Access Compliance Report Public Rights-of-Way (Curb Ramps)

Main Street: GARLAND_AVE Cross Street: DEAN_ST Location: N

ADA ID: RPAT211109133744 Ramp Type: Type 1 - Perpendicular Diagonal Initial Pass/Fail: Fail Overall Compliance: No Severity Score: 16

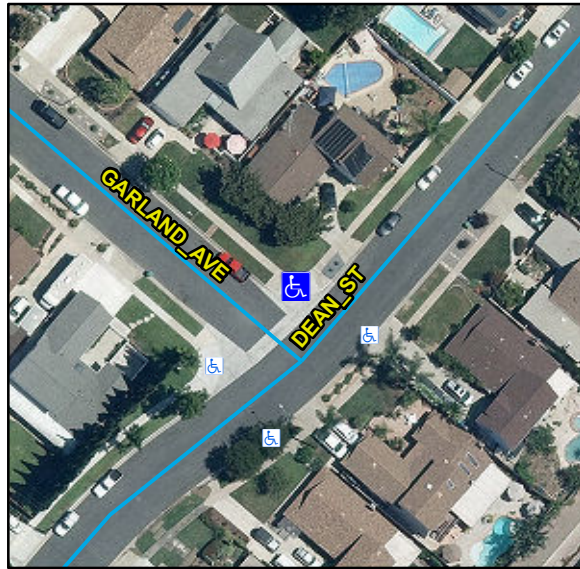
Compliance	Description	Data	Compliance	Description	Data
N/A	Ramp Length (in)	75	N/A	Flare Type LT	
Yes	Ramp Width (in)	49			N/A
No	Ramp Run Slope (%)	8.4	N/A	Flare Slope LT (%)	N/A
Yes	Ramp Cross Slope (%)	0.7	N/A	Flare Traversable LT	N/A
N/A	Landing Present	N/A	N/A	Flare Type RT	
N/A	Landing Length (in)	N/A			N/A
N/A	Landing Width (in)	N/A	N/A	Flare Slope RT (%)	N/A
N/A	Landing Run Slope (%)	N/A	N/A	Flare Traversable RT	N/A
N/A	Landing Cross Slope (%)	N/A	N/A	DWS Provided	N/A
N/A	Landing Movement Obstructed?	N/A	N/A	DWS Contrast	N/A
	Landing Movement Type	N/A	N/A	DWS Length (in)	N/A
N/A	Landing Shared	N/A	N/A	DWS Full Width	N/A
N/A	Clear Space	Yes	N/A	DWS Offset Left (in)	N/A
N/A	Clear Space To Crosswalk (in)	N/A	N/A	DWS Offset Right (in)	N/A
N/A	Marked Crosswalk 1	No	N/A	Marked Crosswalk 2	No
	Crossing 1 Direction	SW		Crossing 2 Direction	SE
	Marked Crosswalk 1 Width (in)	N/A		Marked Crosswalk 2 Width (in)	N/A

N/A	Ramp Inside Crosswalk 1	N/A	Yes	Ramp Inside Crosswalk 2	N/A
	Crossing 1 Slope (%)	1.6		Crossing 2 Slope (%)	5.9
	Crossing 1 Cross Slope (%)	0.9		Crossing 2 Cross Slope (%)	0.2
N/A	Gutter Ponding	N/A	No	Curb Slope	8.2
Yes	Gutter Lip Height (in)	0		Road Run Slope (%)	0.2
N/A	Gutter Run Slope (%)	N/A		Road Cross Slope (%)	1.5
N/A	Gutter Cross Slope (%)	N/A			
Yes	Overall Surface Condition: Acceptable		Yes	Perp Joint Present	Yes
	Cross Gutter Present?	Yes		Spandrel Present?	Yes
	Replace Cross Gutter?	No		Replace Spandrel?	No

Remove & Replace Curb Ramp With Two New Directional Ramps or Equivalent.

R304.2.2, STD 1115
